Subject: Manchester Farms
Lot 104 – Drainage Correction Update

To: Board of Supervisors
Cc: Joe Sciandra, Dewey Homes
Dan Daley, P.E., E.B. Walsh & Associates, Inc.
Denis Branca & Megan Kile
From: Chris Della Penna, P.E.
Date: December 3, 2009
Subject: Manchester Farms
Lot 104 As-Built Plan Review

AS-BUILT PLAN
FOR
MANCHESTER FARMS SUBDIVISION
LOT 104

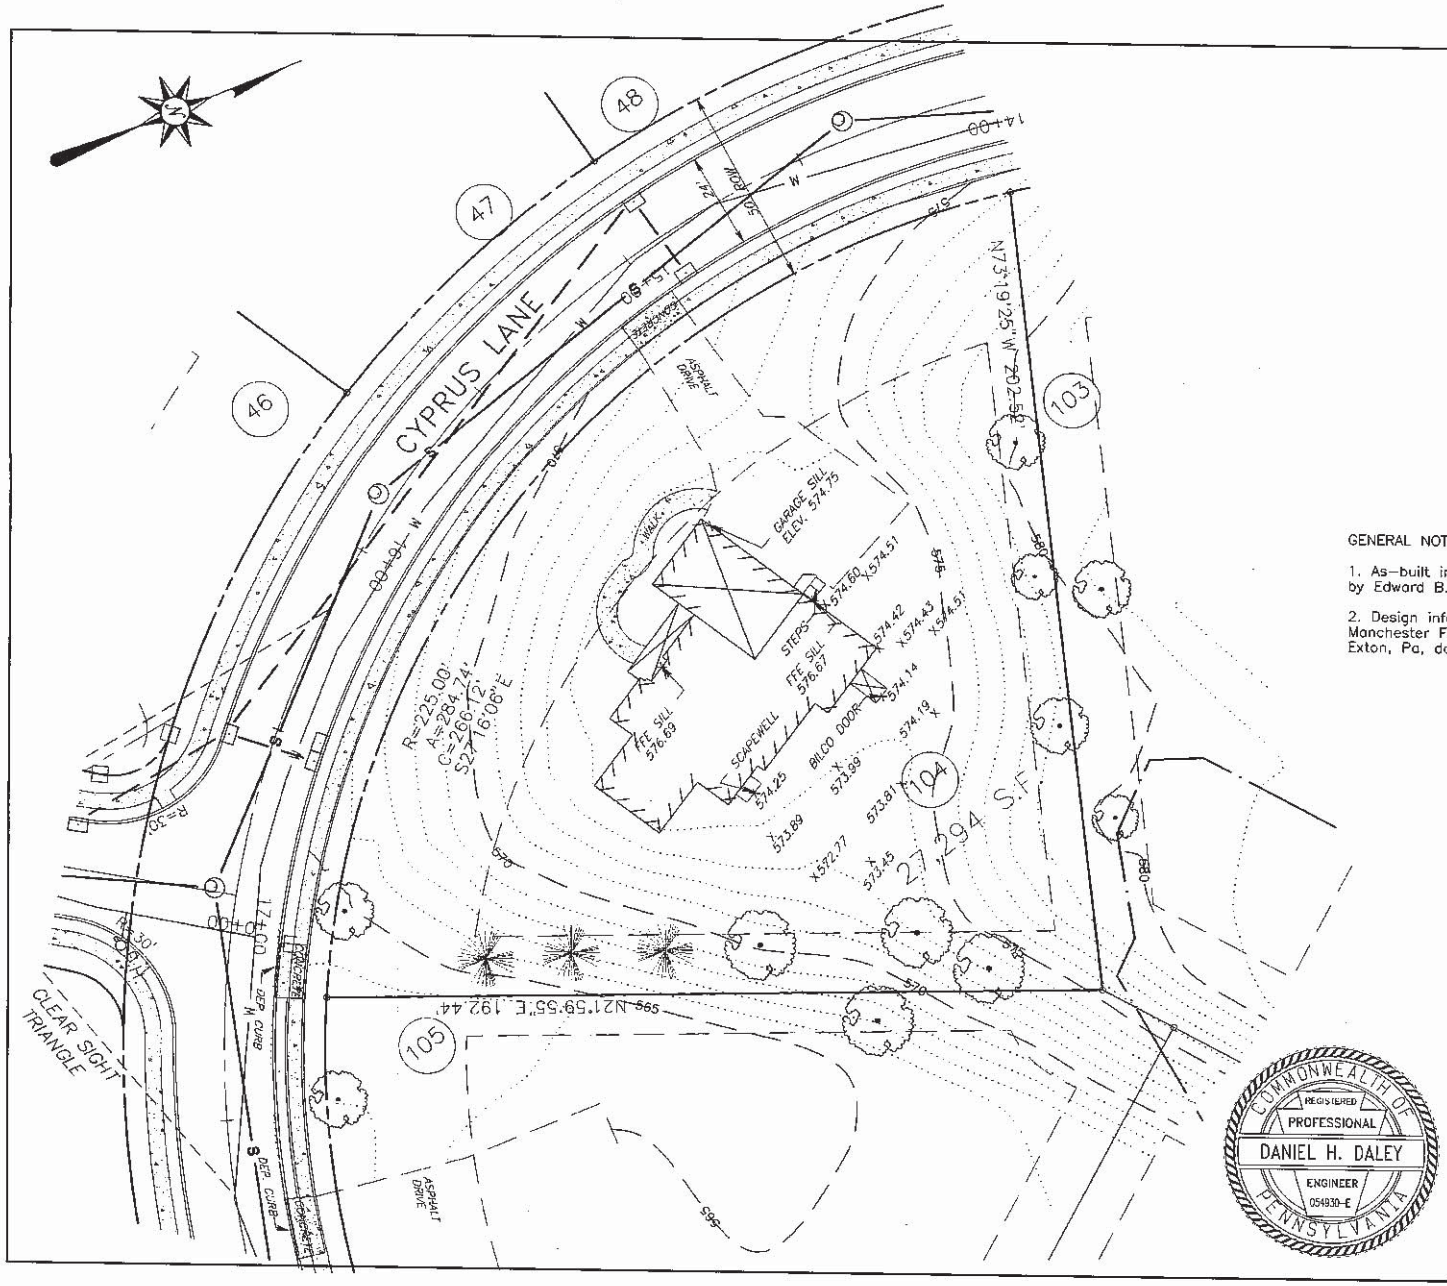
An As-Built Plan for the above-referenced lot has been submitted for review. The plan was prepared by E. B. Walsh & Assoc., Inc. dated 8/4/09. As requested, I have reviewed this plan for consistency with the approved Building Permit Plan for this same lot that was approved on February 19, 2007. The following was noted:

1. The approved swale along the north side of the house to convey runoff from the uphill lots was not installed.
2. The driveway parking area was constructed wider and the embankment north of the driveway was not graded back as far as depicted on the approved plan. This therefore limits the ability to install the above noted swale shown on the approved plan.

3. The area behind the house between the Bilco door and the driveway is too flat and cannot drain properly as originally designed.
4. The Bilco door was installed where a deck was proposed on the approved plan. The elevation of the lip of this door also appears to be lower than the surrounding ground, which could result in water entering the basement through the door.

5. It does not appear as if all the street trees and shrubbery in the rear yard have been planted.
6. The as-built first floor elevation of the house is approximately 1.68 +/- feet higher than that proposed on the approved plan.

As noted above, there are several points of concern regarding the as-built conditions of this lot, which would contribute to the drainage problems currently being experienced by the homeowners. The builder should within 30 days submit a plan of redesign depicting how these issues will be addressed. The plan must be reviewed and approved by the Township and the homeowners before any corrective measures are implemented.
